Docket No. 50-336
B14445

Millstone Nuclear Power Station, Unit No. 2
Proposed Revision to Technical Specifications
Pressure/Temperature Limits
Marked Up Pages of Technical Specifications

June 1993

Proposed Revision to Technical Specifications
Pressure/Temperature Limits
Retyped Pages of Technical Specifications

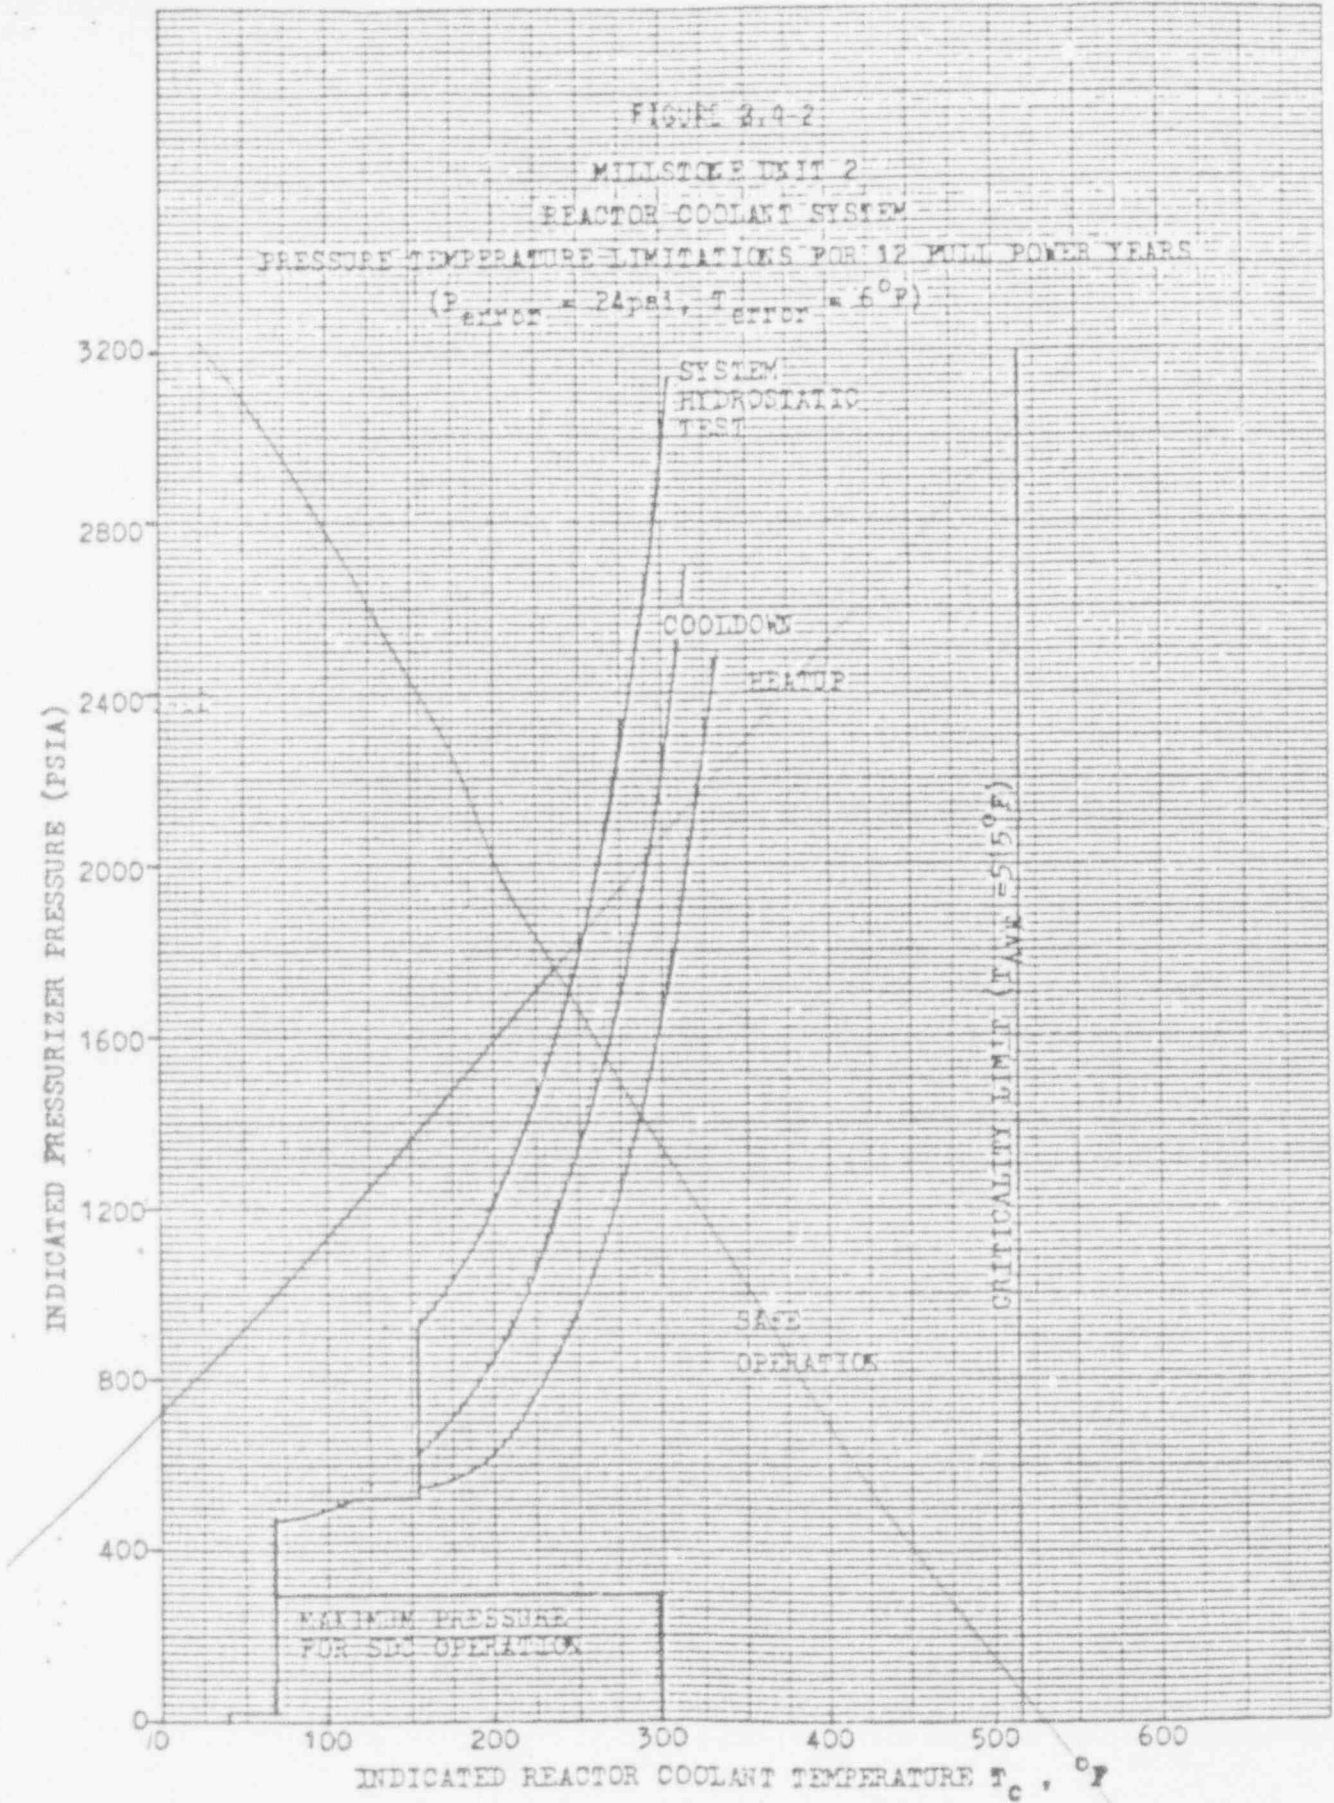
The reactor vessel materials have been tested to determine their initial RT_{NDT} ; the results of these tests are shown in Table 4.6-1 of the Final Safety Analysis Report. Reactor operation and resultant fast neutron irradiation will cause an increase in the RT_{NDT} . Therefore, an adjusted reference temperature, based upon the fluence, can be predicted using the methods described in ~~SECY 82-065, "NRC Staff Evaluation of Pressurized Thermal Shock," November 1982. Because it is more conservative, this method was used rather than the proposed~~ Revision 2 to Regulatory Guide 1.99.

The actual shift in RT_{NDT} of the vessel material will be established periodically during operation by removing and evaluating, in accordance with ~~ASTM E105-73~~, reactor vessel material irradiation surveillance specimens installed near the inside wall of the reactor vessel in the core area. Since the neutron spectra at the irradiation samples and vessel inside radius are essentially identical, the measured transition shift for a sample can be applied with confidence to the adjacent section of the reactor vessel. The heatup and cooldown curves must be recalculated when the ΔRT_{NDT} determined from the surveillance capsule is different from the calculated ΔRT_{NDT} for the equivalent capsule radiation exposure.

FIGURE 3.4-2

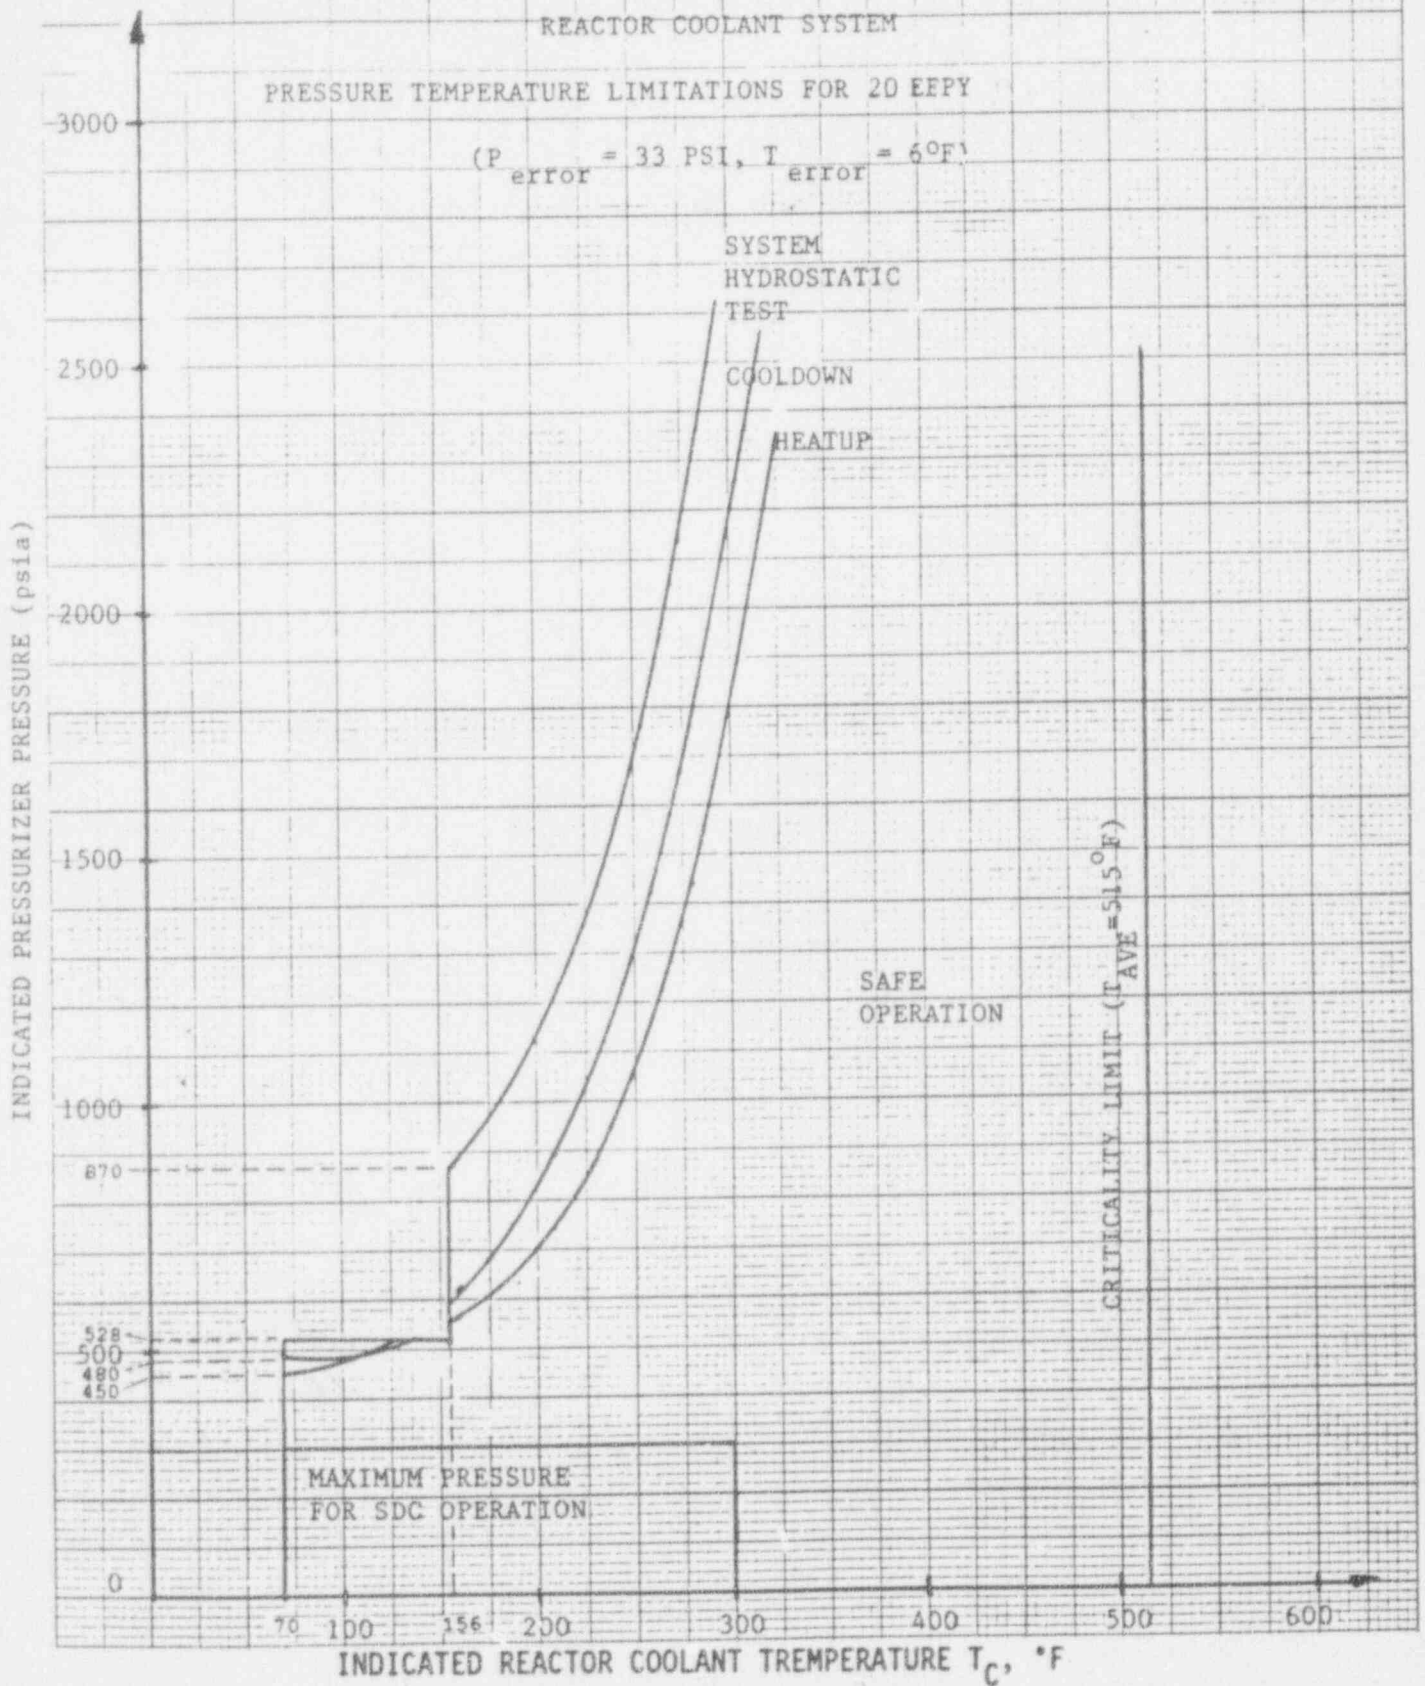
PRESSURE TEMPERATURE LIMITATIONS FOR 20 EEPY

($P_{error} = 33 \text{ PSI}$, $T_{error} = 6^{\circ}\text{F}$)

The heatup and cooldown limit curves shown on Figure 3.4-2 include predicted adjustments for this shift RT_{NDT} at the end of the applicable service period, as well as adjustments for possible errors in the pressure and temperature sensing instruments.
